Region of Waterloo

**Re: Zone Change Application ZCA 01/10
Cambridge Aggregates Inc.
1182 Alps Road
Township of North Dumfries**

The Region has received the above-noted application and provides the following comments for the Township's consideration. The purpose of the application is to rezone the subject properties from Agricultural (Z1) to Extractive (Z14) to permit the expansion of the existing Cambridge Aggregates North Dumfries pit located at 1182 Alps Road.

BERM & ROAD WIDENING PLAN
 SPRAGUES ROAD - REGION ROAD 75
 Township of Aprin Dumfries
 Region of Waterloo

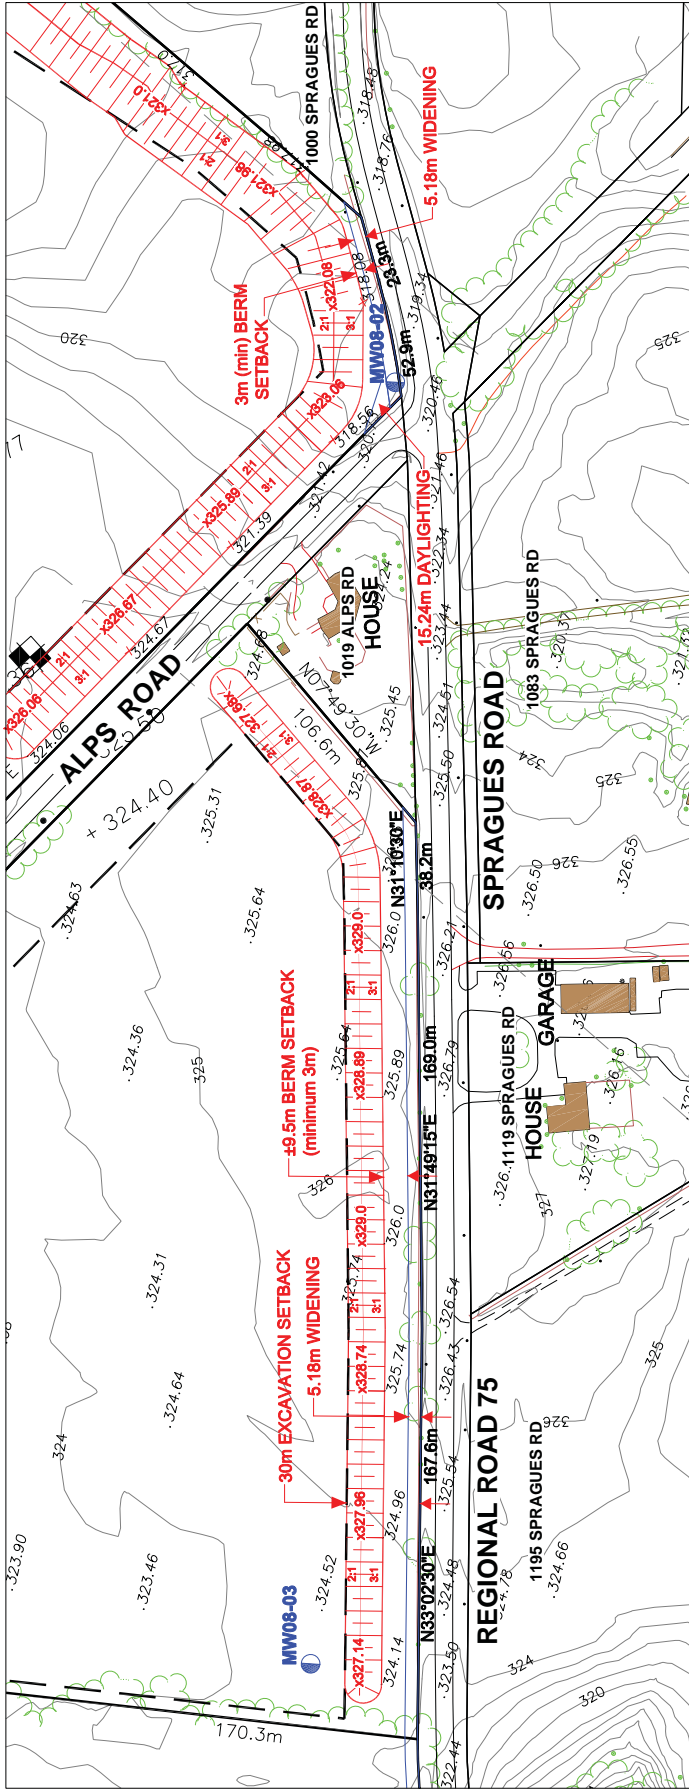
I have attached an enlarged plan of the proposed berms adjacent to Spragues Road.

North of Alps, the berm will not affect the drainage or proposed widening. Our groundwater monitor MW08-02 appears to be within the road widening. We would expect that it can remain.

South of Alps, we have extended the berm to the south boundary of the proposed pit, at the request of a neighbour. The berm can be about 9 m from the road allowance to enable conveyance of your proposed 5.18 m widening and maintain a 3 m setback. As our soil and water resources reports indicate, the adjacent field drains internally. There are no watercourses. Consequently, boulevard water which flows toward the berm should not cause a drainage problem. The existing road ditches should be maintained by the Region, to handle roadway drainage.
